COOPER NUCLEAR STATION

AMENDMENT TO FACILITY OPERATING LICENSE

Amendment No. 173  
License No. DPR-46

ATTACHMENT TO LICENSE AMENDMENT NO. 173

FIGURE 3.4.1

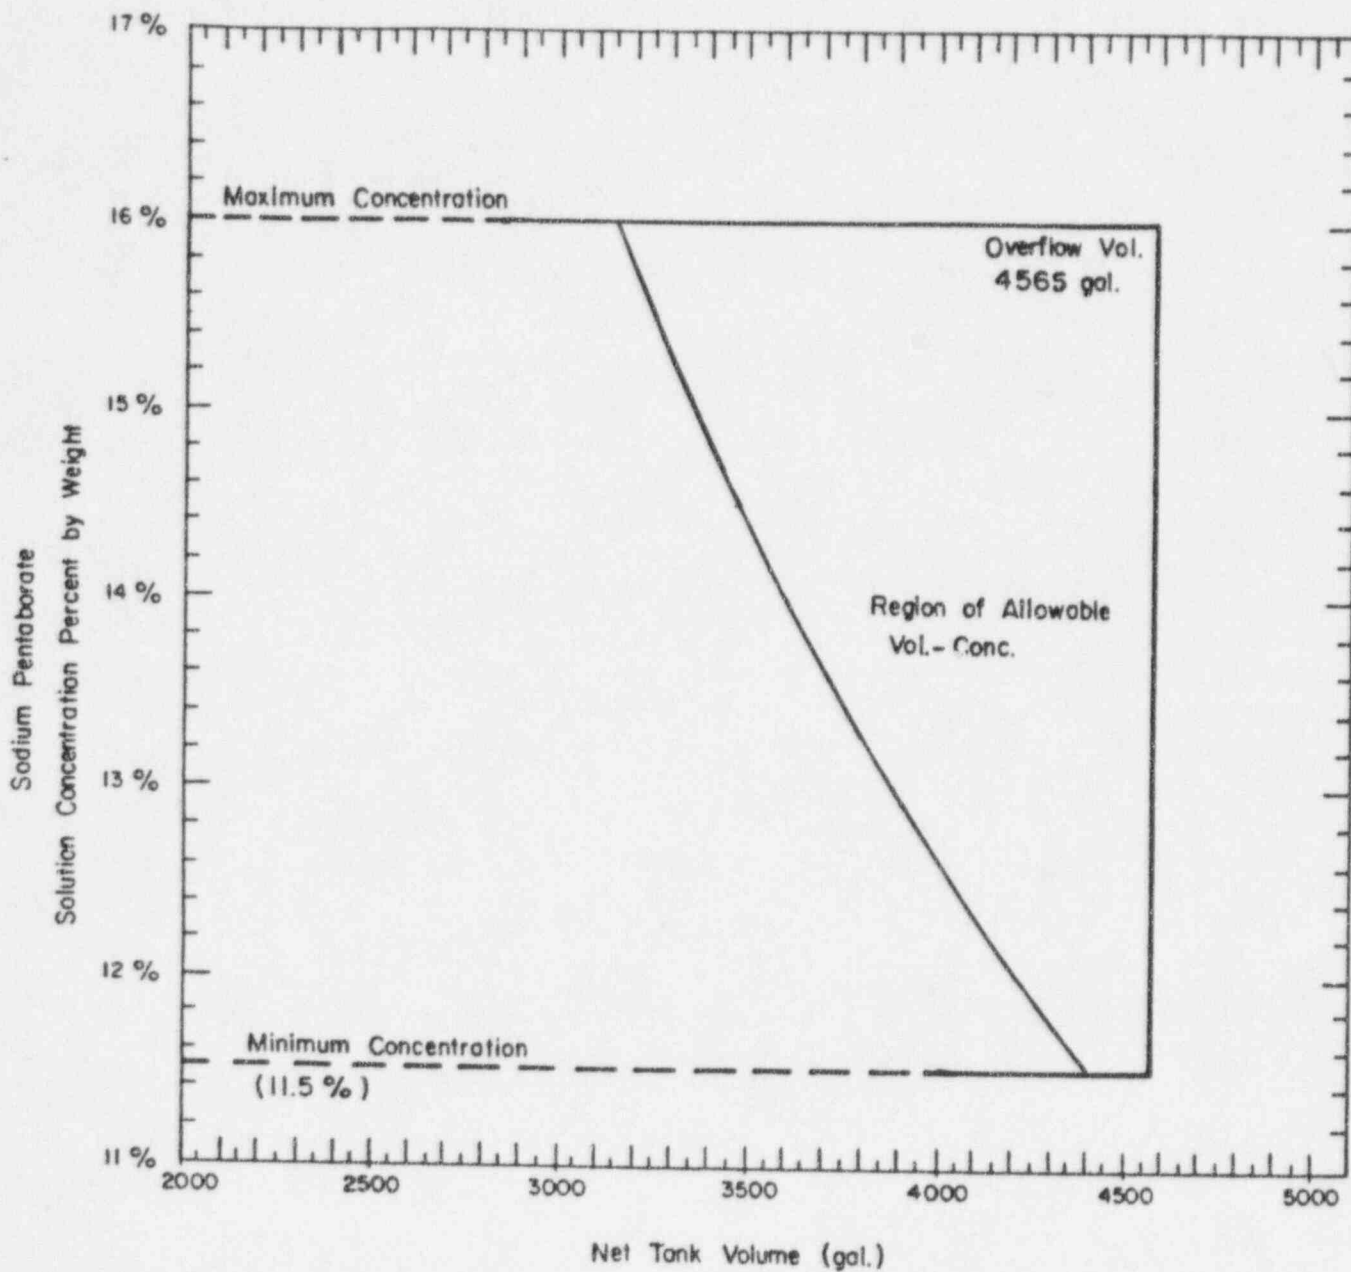
1. The net volume versus concentration of the liquid control solution in the SLC Storage Tank shall be maintained as required in Figure 3.4.1.
2. The temperature of the liquid control solution shall be maintained above the curve shown in Figure 3.4.2.

The quantity of stored boron includes an additional margin (25 percent) beyond the amount needed to shutdown the reactor to allow for possible imperfect mixing of the chemical solution in the reactor water. A minimum quantity of 3132 gallons of solution having a 16.0 weight percent sodium pentaborate concentration, or the equivalent as shown in Figure 3.4.1, is required to meet this shutdown requirement.
